SUNDRY NOTICES AND REPORTS ON WELLS Do not use this form for proposals to drill or to re-enter an abandoned well. Use form 3160-3 (APD) for such proposals.

1. Type of Well [] Oil Well [x] Gas Well [] Other
2. Name of Operator YATES PETROLEUM CORPORATION Contact: TINA HUERTA
3a. Address 105 SOUTH 4TH STREET ARTESIA, NM 88210
3b. Phone No. (include area code) Ph: 575-748-4168
4. Location of Well (Footage, Sec., T., R., M., or Survey Description) Sec 1 T8S R25E NWNW 660FNL 660FWL

WELL NAME: Gerry Fed #1 FIELD: Pecos Slope Abo

Permanent Abandonment of Federal Wells Conditions of Approval

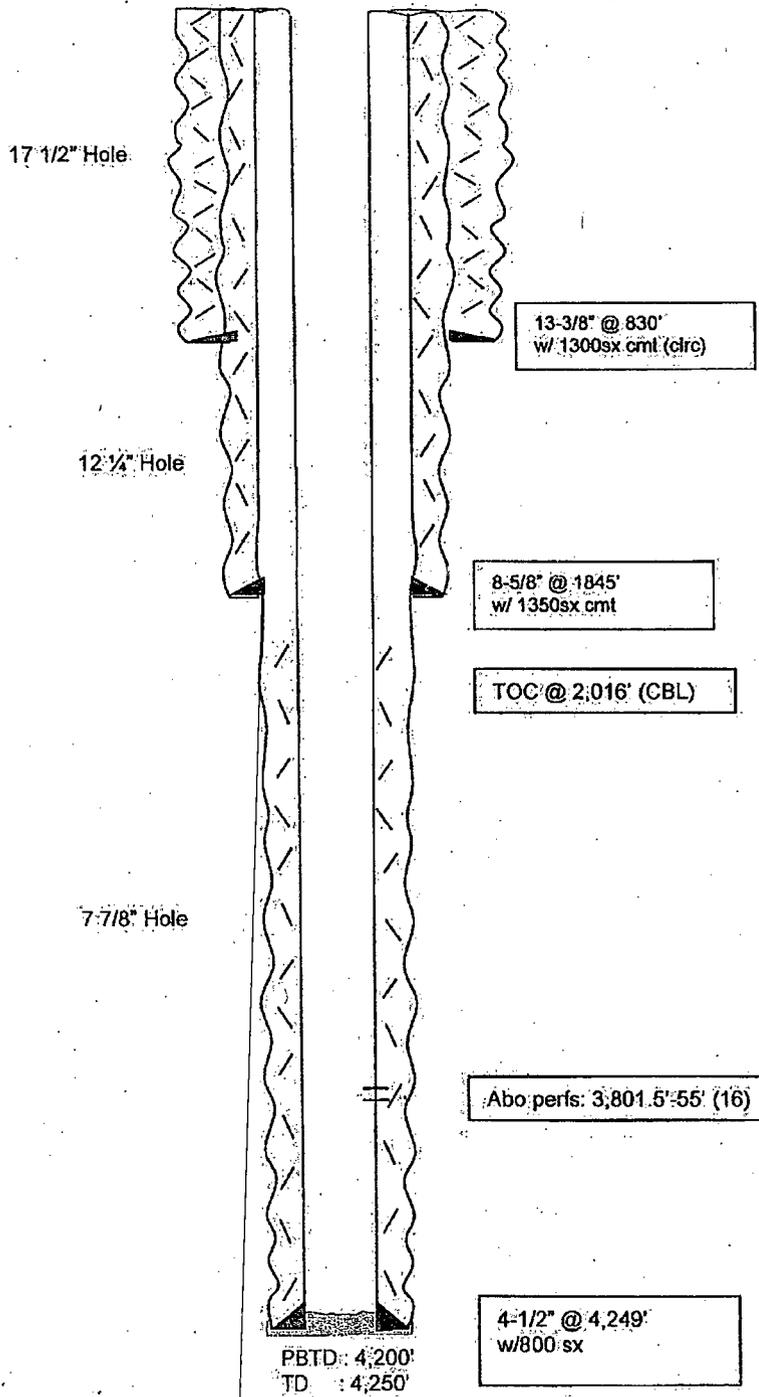
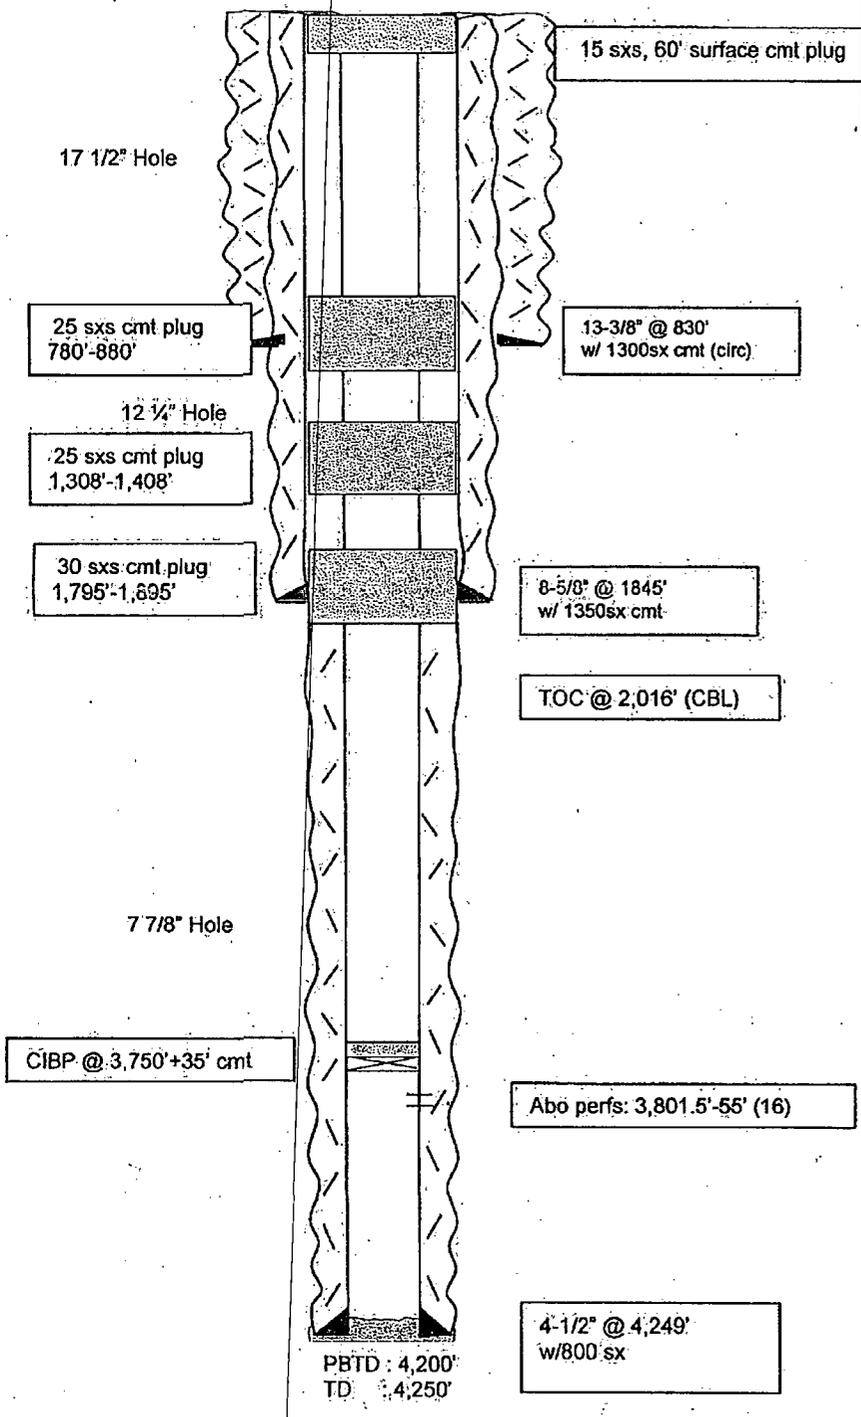
13. Describe Proposed or Completed Operation (clearly state all pertinent details, including estimated starting date of any proposed work and approximate duration thereof. Yates Petroleum Corporation plans to plug and abandon this well as follows: 1. MIRU WSU. Rig up any safety equipment as needed. No casing recovery will be attempted. POOH with tubing. 2. Set a CIBP at 3750 ft and cap it with 35 ft cement. This puts a plug over Abo. witness 3. Perforate at 1895 ft and spot a 30 sx Class C cement plug from 1795 ft -1895 ft. This puts a 100 ft plug across intermediate casing shoe, inside and outside casing. WOC and tag plug. witness 4. Perforate at 1408 ft and spot a 25 sx Class C cement plug from 1308 ft -1408 ft. This puts a 100 ft plug across top of Glorieta, inside and outside casing. witness 5. Perforate at 880 ft and spot a 25 sx Class C cement plug from 780 ft - 880 ft. This puts 100 ft plug across surface casing shoe, inside and outside casing. WOC and tag plug. witness 6. Perforate at 60 ft and spot a 15 sx Class C cement plug from 60 ft up to surface. witness

7. Remove all surface equipment, weld dry hole marker and clean location as per regulations.
